PARK CITY PLANNING COMMISSION MEETING
SUMMIT COUNTY, UTAH
July 23, 2025

5.A. **301 Marsac Avenue – Plat Amendment** – The Applicant Proposes Creating a 3,750-Square-Foot Lot to Construct a New Single-Family Dwelling on Very Steep Slopes in the Historic Residential - 1 Zoning District. PL-23-05947
(A) Public Hearing; (B) Continue to August 13, 2025

PARK CITY MUNICIPAL CORPORATION
PLANNING COMMISSION MEETING MINUTES
COUNCIL CHAMBERS
MARSAC MUNICIPAL BUILDING
JUNE 25, 2025

A1.4

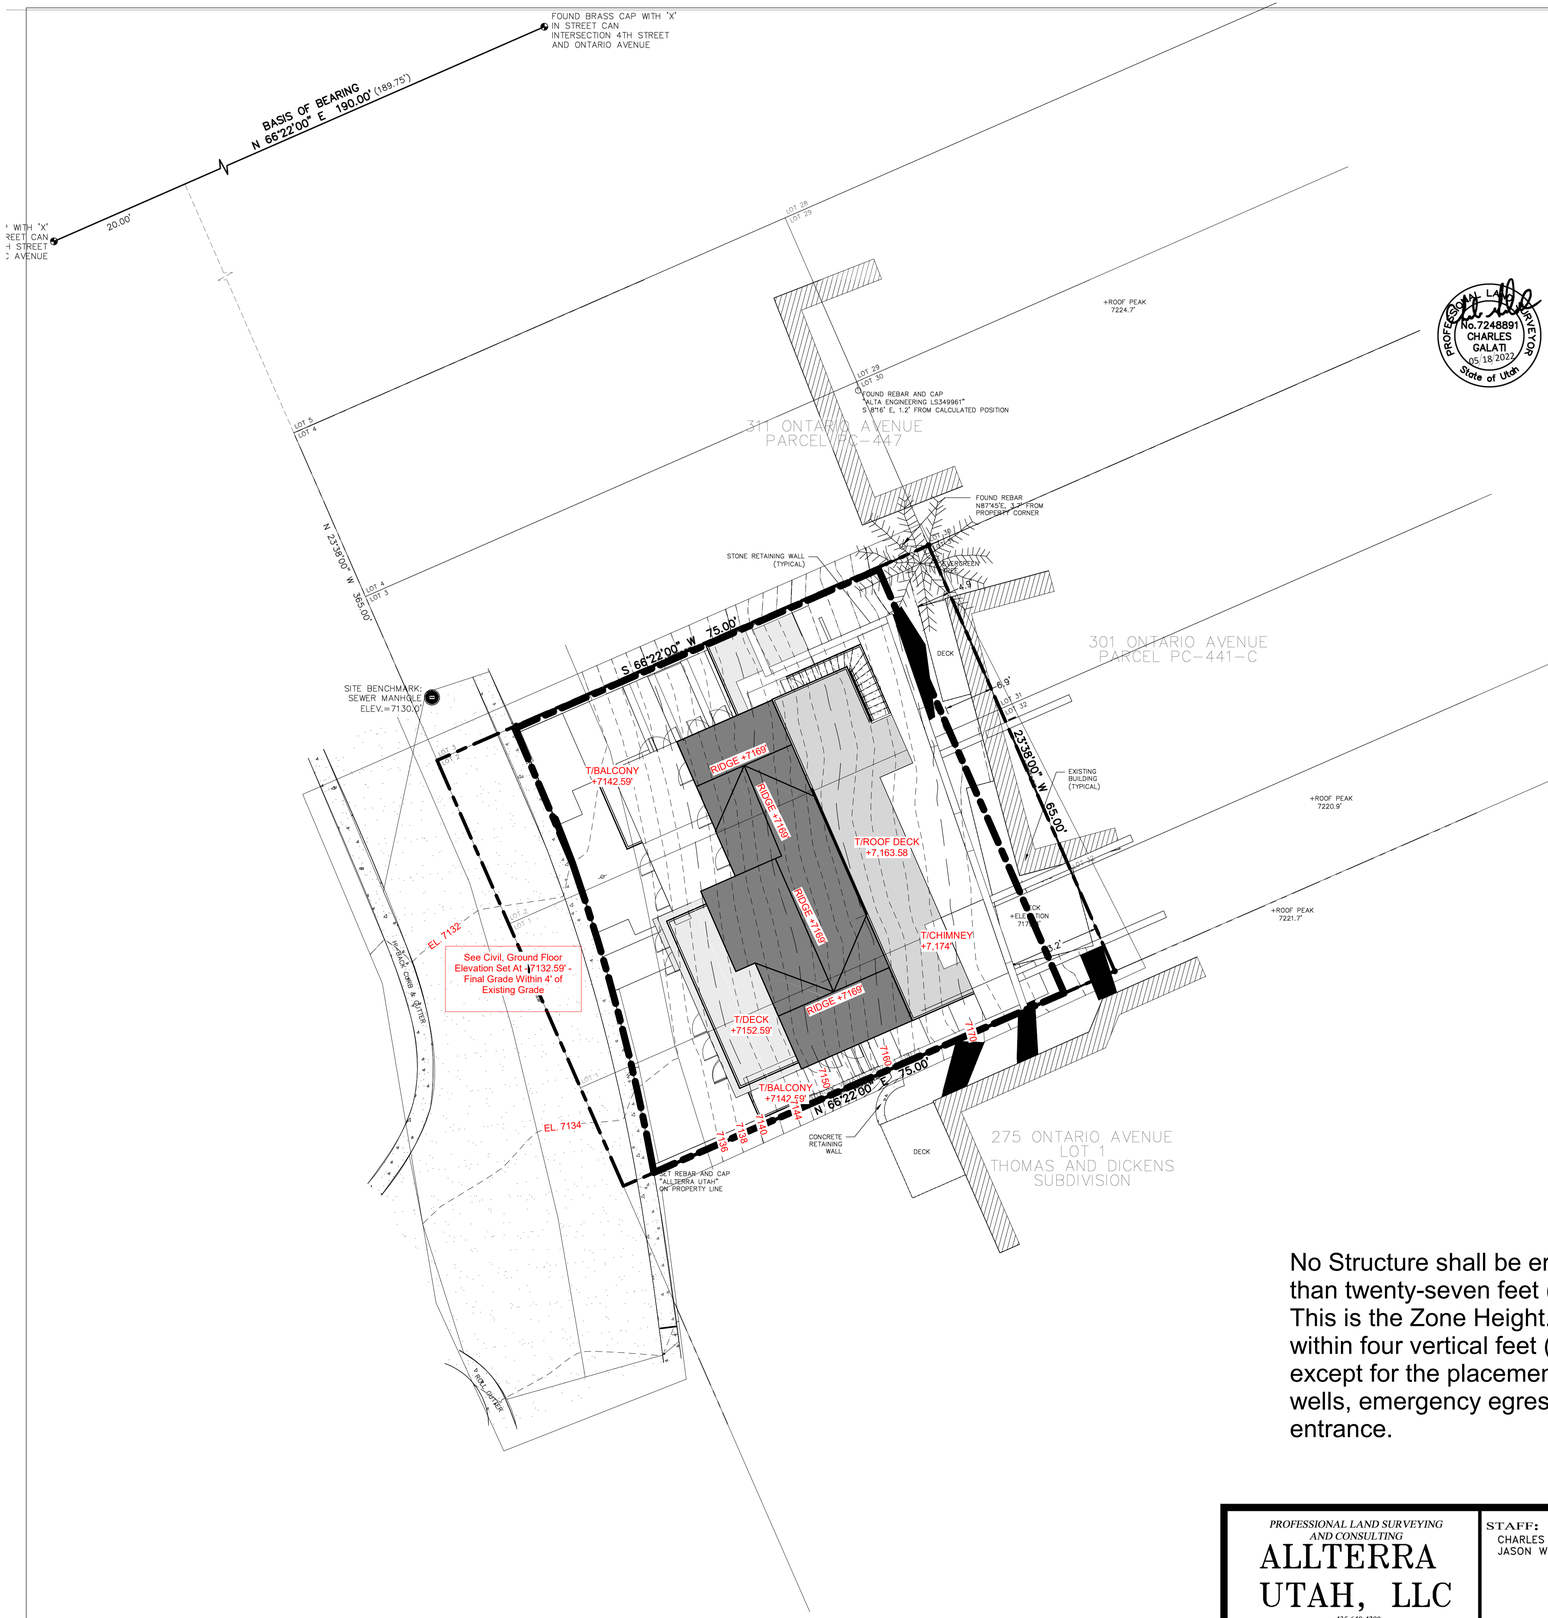
Commissioner Suesser believes a missing component has to do with the top roof deck area that shows the rear retaining wall and the fact that there is no terracing anticipated with this proposal. She would recommend that the applicant remove that top deck and create terracing there. She also feels it makes sense to remove the accessory building. Commissioner Suesser pointed out that this application has slopes of 90% to 100%. She is not certain that this application will be able to come into compliance due to the topography. The very steep slopes will make it difficult to meet the SSCUP criteria.
